Note: The Scope of this project is the milling and overlay of parking lot as shown. Striping will be identical to Existing.

ENGINEER'S SEAL DAVID SOULE P.E. #14522	MANUAL SHOPPING CENTER STRIPING /TCL PLAN	DRAWN BY WCUJ DATE 9-01-10 2128-LAYOUT-8-23-10 SHEET #
	 Rio Grande Engineering 1606 CENTRAL AVENUE SUITE 201 ALBUQUERQUE, NM 87106 (505) 872-0999	JOB # 2129

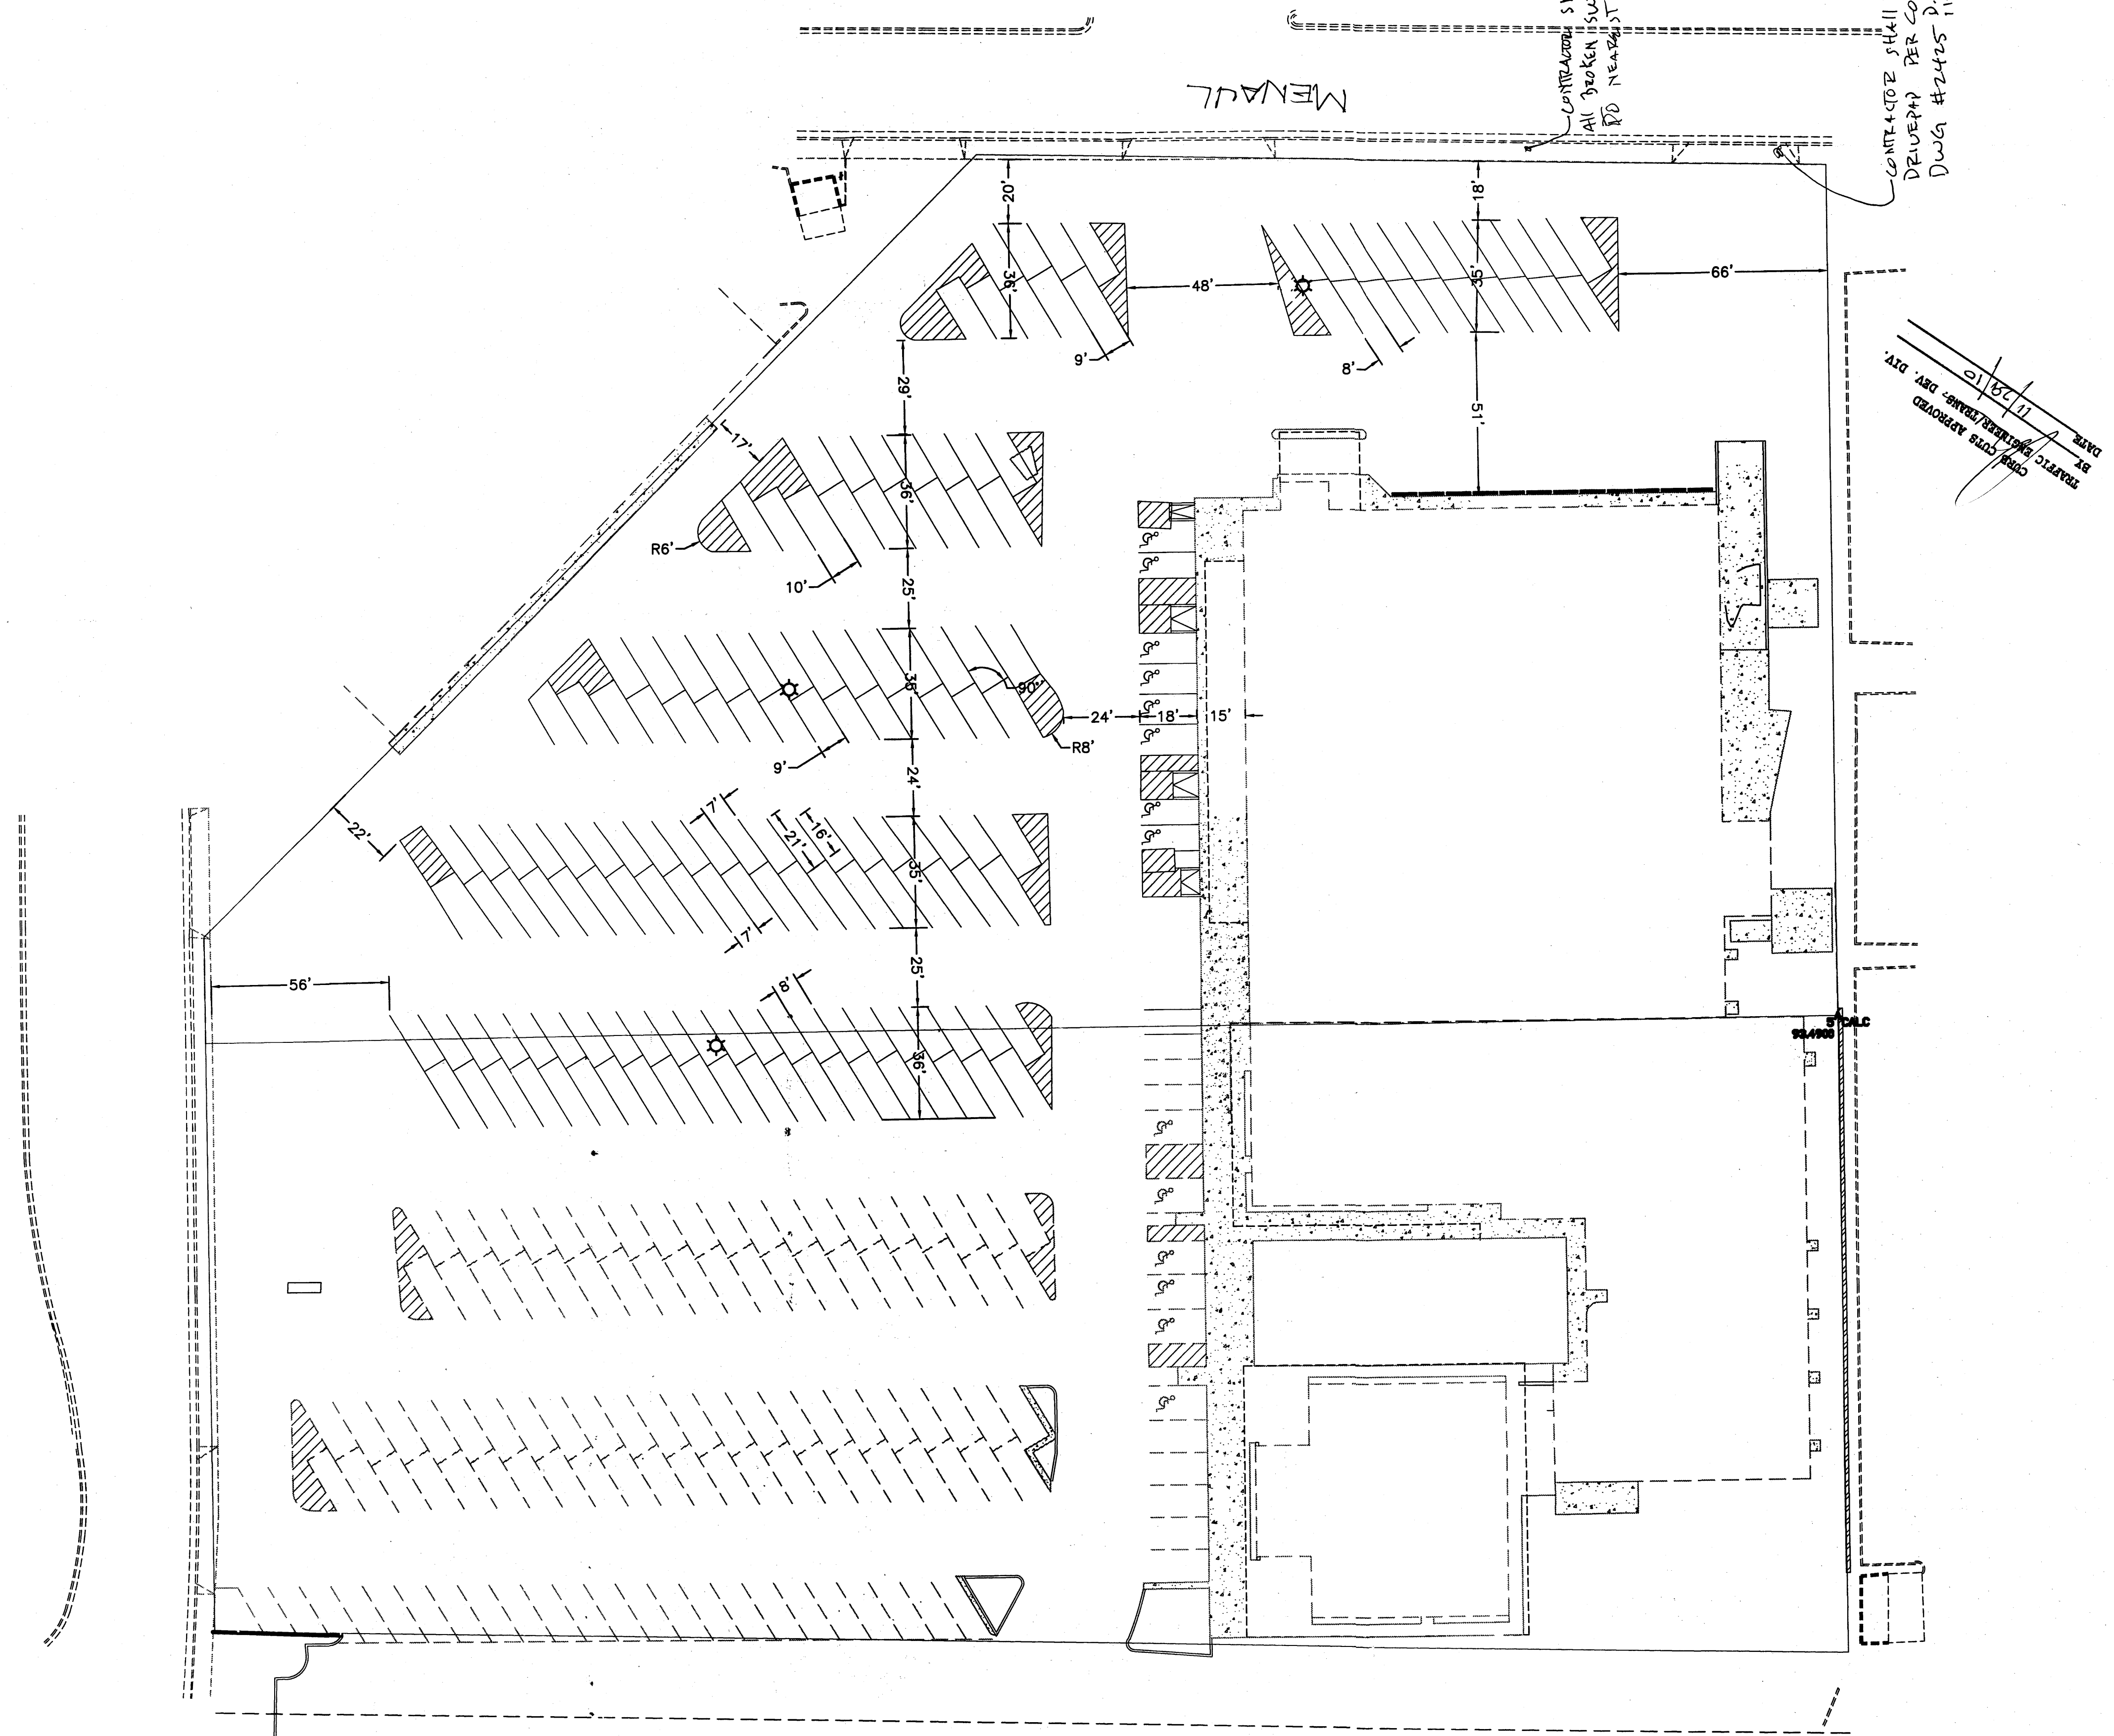
CONTRACTOR SHALL REBUILD
DRIVEWAY PER COA JTP
DWG #2425 11-25-10

CONTRACTOR SHALL REPAIR
ALL BROKEN SLOW STONES
TO NEAREST JOINT
D.S.
11-24-10
